Subject: AP1000 COL Responses to Requests for Additional Information (TR #24)

In support of Combined License application pre-application activities, Westinghouse is submitting responses to NRC requests for additional information (RAI) on AP1000 Standard Combined License Technical Report 24, APP-GW-GLR-060, Rev. 0, Reactor Vessel Insulation System – Verification of In-Vessel Retention Design Bases. These RAI responses are submitted as part of the NuStart Bellefonte COL Project (NRC Project Number 740). The information included in the responses is generic and is expected to apply to all COL applications referencing the AP1000 Design Certification.

AP1000 TECHNICAL REPORT REVIEW

From Figure 2.4 in ULPU Configuration V Test Report

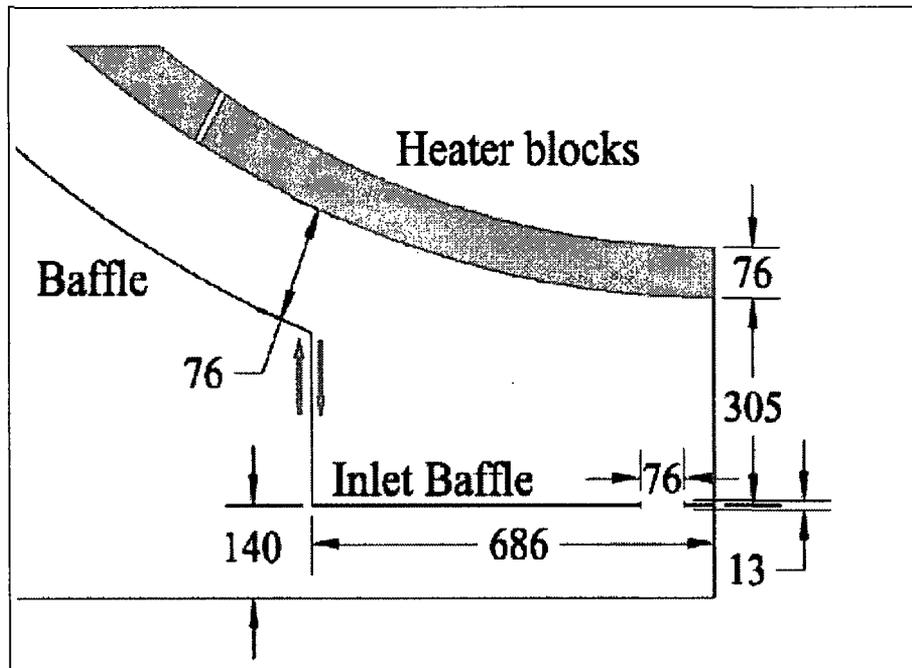
- a) For example, report CRSS-03/06 “Limits of Coolability in the AP1000-Related ULPU-2400 Configuration V Facility” indicates that the inlet baffle is “plugged” during normal operation using floating balls. (The report does not state whether or not such balls were used during the test to check their ability to open the inlet baffle when needed.) However, the proposed design of the Reactor Vessel Insulation System (RVIS) in TR #24 (with elaboration in report APP-MN20-Z0R-001 R0) has been modified to use inlet assemblies with buoyant doors, instead of floating balls.

Please confirm that the impacts of these design modifications are bounded by the configuration(s) tested in the ULPU-2400 Configuration V Facility, and explain why this is so.

Since simulating the buoyant balls passively floating open was not one of the purposes of the ULPU testing, the balls were not included in the test. Rather the test assumed that the balls would always open and water would freely flow into the AP1000 inlet assembly. The passive actuation feature of buoyancy initiating the IVR flow is retained with the current four door design.

The figure above is from the ULPU Configuration V test report and shows the test configuration that simulates the inlet assembly. In the test, water entered the inlet assembly through a 76 mm hole in the inlet baffle. The hole was sized to provide a flow area that matched the test scale. The test provides representative IVR results for any inlet assembly design that does not impose a greater flow resistance than the test. A lower flow resistance than the test improves mass flow which enhances in-vessel retention (IVR) performance over that predicted by the test.

The AP1000 design provides a flow area through four doors which exceeds the minimum required area by 33-1/3%. In addition the door design provides a lower flow resistance than modeled in the ULPU Configuration V test.

At the top of the inlet assembly, the bottom head insulation has a circular opening to allow water from the inlet assembly to flow into the annulus between the reactor vessel and the RVIS. The radius of the opening in the insulation panels (686 mm shown in the above figure) is the same for the ULPU Configuration V test and for the AP1000 RVIS design.

The lower flow resistance of the AP1000 inlet assembly design enhances the IVR performance observed in the ULPU Configuration V testing.

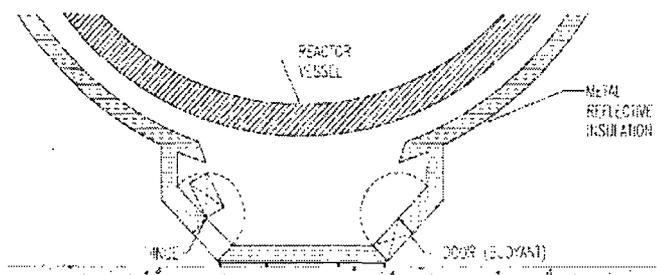
- a) Diagrams in report APP-MN20-Z0R-001 R0 suggest that the inlet assemblies are not at the very bottom of the RVIS structure, but appear to be located some number of degrees of arc away from the very bottom, side-by-side, circumferentially around the structure. The buoyant doors appear to be hinged “on top”, such that the incoming water is expected to force them open in an upward swinging motion.

When the water that enters the annulus makes initial contact with the RPV, it is conceivable that there could be a significant amount of flashing to steam which could locally pressurize this region of the annulus. Because of the way the doors are hinged to “swing upward”, it appears that the local pressurization could be felt “behind the doors”, and possibly impose a closing force on them, which may or may not be greater than the buoyant force trying to open them. The net force calculations in APP-MN20-Z0R-001 R0 did not appear to consider this potential “dynamic backpressure”.

Please provide analytical and/or experimental evidence that the inlet doors, as currently configured will still open sufficiently to provide the required flow area cross-section as specified in APP-GW-GLR-060, given the above potential dynamics.

- b) In addition, with the water initially entering some number of degrees of arc away from the very bottom, it is conceivable that in the course of this process, the motion of the flows could turn into eddy currents that could conceivably have an impact on the doors’ ability to remain sufficiently open. Please provide analytical and/or experimental evidence that such phenomena will not occur to the point of impairing the ability of the doors’ buoyancy to sufficiently open and remain sufficiently open during the ERVC process.
- c) Please provide evidence (geometric and/or otherwise) that the thickness of the inlet

doors will not encounter physical interference from the adjoining RVIS structure during the opening motion. Please take the impact of environmental temperatures (with the potential for differential thermal expansion) and radiation fields during prior normal operation into account in your explanation.

- a) As shown in Reference 1, the water inlet doors are located on the lower part of four sides of a hopper-shaped inlet assembly. This inlet assembly is located below an opening in the center bottom of the insulation on the bottom head of the reactor vessel. The bottom of each door is inches above the floor of the reactor cavity.

The hopper has flat sloping sides and each side has one door. The doors are spaced so that no door impedes the action of another. The doors are buoyant and therefore float open with water rising in the reactor cavity during an accident. Water pressure or momentum from inward flowing water is not required to open the doors. The following figure from Reference 1 provides a pictorial.

For clarity, this pictorial only shows two of the four doors. For reference purposes, the door on the right is shown closed and the door on the left is shown in its open position due to buoyancy. All doors would normally be in the same degree of openness.

The center of gravity of the open door is at the intersection of the dashed diagonal lines connecting opposite corners of the door. The center of buoyancy of the doors is in the same location as their center of gravity. In the open position due to buoyancy alone, the center of gravity of each door is over its hinge. The door reaches this position well before the water level reaches the reactor vessel bottom head.
